Panel Reference	PPSSNH-402
DA Number	DA-2023/166
LGA	Willoughby
Proposed Development	Mix of concept, construction and use and staged development. Nominated Integrated Development - Water Management Act 2000 s90 (WaterNSW). Development Application - Demolition of existing structures, removal of all trees, residential flat building containing 89 residential units, amendments to the layout and arrangement of 'communal' space, 4 levels of basement parking containing 57 car spaces, landscaping and associated works, through-site links, strata subdivision.
Street Address	691-699 Pacific Highway, Chatswood
Applicant/Owner	DPG 38 Pty Ltd c/o- JV Urban
Date of DA lodgement	28 June 2023
Number of Submissions	Eight (8)
Recommendation	Refusal
Regional Development Criteria - Schedule 6 of the SEPP (Planning Systems) 2021	Development that has a capital investment value of more than \$30 million.
List of all relevant s4.15(1)(a) matters	<ul style="list-style-type: none"> • State Environmental Planning Policy (Biodiversity and Conservation) 2021 • State Environmental Planning Policy (Resilience and Hazards) 2021 • State Environmental Planning Policy (Transport and Infrastructure) 2021 • State Envir

Image 7: Through-site links proposed by Draft Precinct DCP (Source: Draft Precinct DCP, Figure 1)

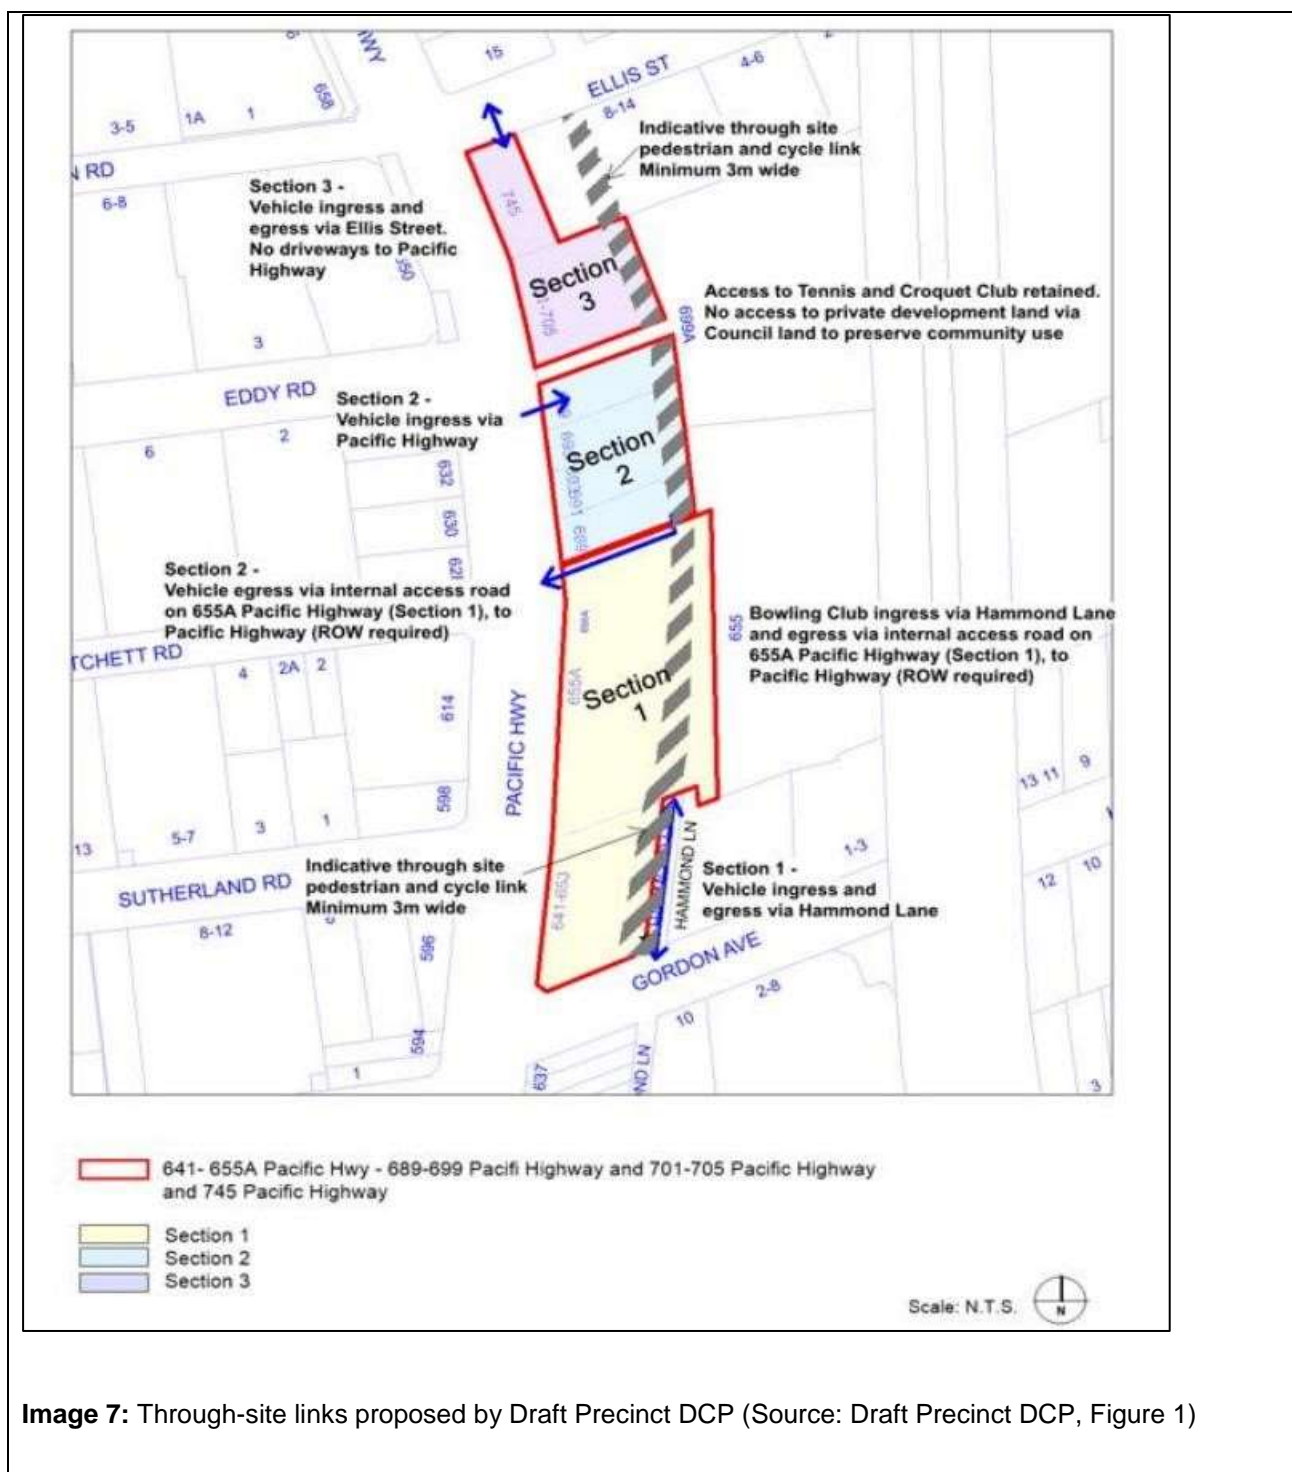
The Draft Precinct DCP contemplates lands within the precinct being amalgamated into three blocks — one block comprising the Site and the neighbouring property immediately to the south, being 689 Pacific Highway. Developments would be required to adopt "through-site links" in accordance with those depicted in Image 7 below:

The Development Application proposes, contrary to the Precinct DCP, that vehicle ingress and egress be secured from a single location, being located on the southern fringe of the Site, on land presently legally described as Lot 1 in Deposited Plan 187216.
